# UNITED STATES PATENT AND TRADEMARK OFFICE

APPLICATION NO.	FILING DATE	FIRST NAMED INVENTOR	ATTORNEY DOCKET NO.	CONFIRMATION NO.
10/646,545	08/21/2003	Douglas S. Hine	P-11138.00	9714

**Office Action Summary**

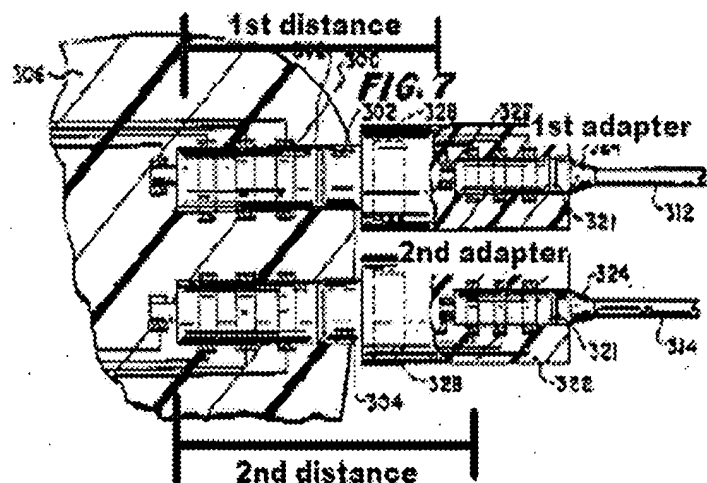
The Applicant has argued that Pohndorf et al. (US 4,628,934) does not show a first distance different from a second distance. The examiner has included a figure below from Pohndorf et al. to display the two different distances. Furthermore, this limitation is a negative limitation that does not have basis in the original disclosure. Therefore, the claims are further rejected under 35 U.S.C. 112 1<sup>st</sup> paragraph.

1. Claims 1, 3-4, 6 and 11-12 stand rejected under 35 U.S.C. 102(b) as being anticipated by Pohndorf et al. (US 4,628,934). Pohndorf et al. discloses a pacemaker with a connector bore for electrically and mechanically connecting the implantable medical device (IMD) with two adaptors and multi-electrode leads as displayed in figures 6 and 7. The array of lead connector elements are displayed in figure 2 as "sleeves 151 and 152 (in contact with rings 141 and 142) (col. 7, lines 63-64)". The sleeves are connected to electrodes, with a conductor for each electrode. The two adaptors, which the examiner considers to be a plurality of adaptors, have an inner lumen for engaging the sleeves of the lead with rings to create an electrical and mechanical connection. In addition, the adaptors have an external surface used for engagement with the electrical bore. This engagement surface has two contact zones, the pin as the first zone and sleeves of the lead as the second zone, which connects within the IMD with the socket and rings, respectively.

As to claims 1 and 11, the examiner has included a replication of figure 7 to display the first and second distances. The examiner considers the first distance is to the first contact zone and the second distance is to the second contact zone. Therefore the first distance is not equal to the second distance.
